**REQUEST**

Current Zoning: R-5 (single family residential) & R-22MF (multi-family residential)  
Proposed Zoning: UR-2(CD) (urban residential, conditional)

**SUMMARY OF PETITION**

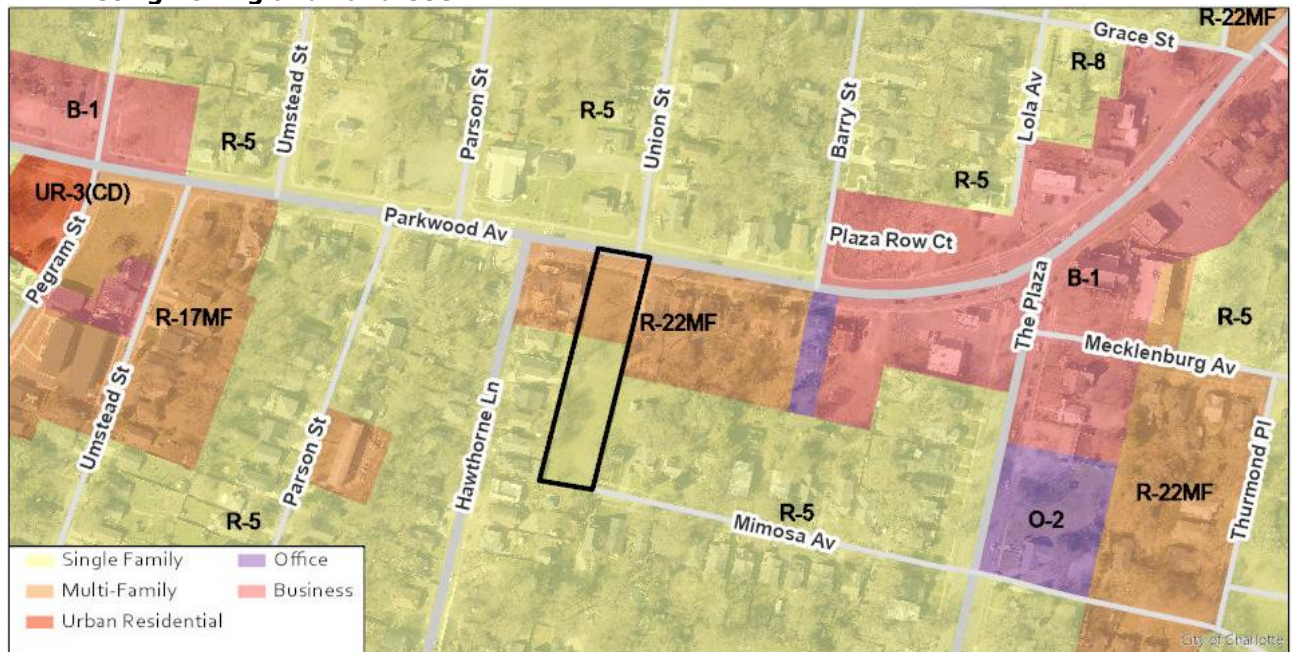
1. Revise the driveway to Mimosa Avenue to meet Charlotte Land Development Standards Manual for two-way circulation since it is a shared driveway.

2. The petitioner should present a design that is more aligned with the future land use of the parcel and reflective of the surrounding residential context that is proximal to the site along Mimosa Avenue and Parkwood Drive. These changes should reflect a reduction in density, height, and overall impervious area of the proposal. The proposed surface parking lot is not supported in any form.

3. Coordinate with Charlotte Fire to resolve the required provision of an approved turnaround.
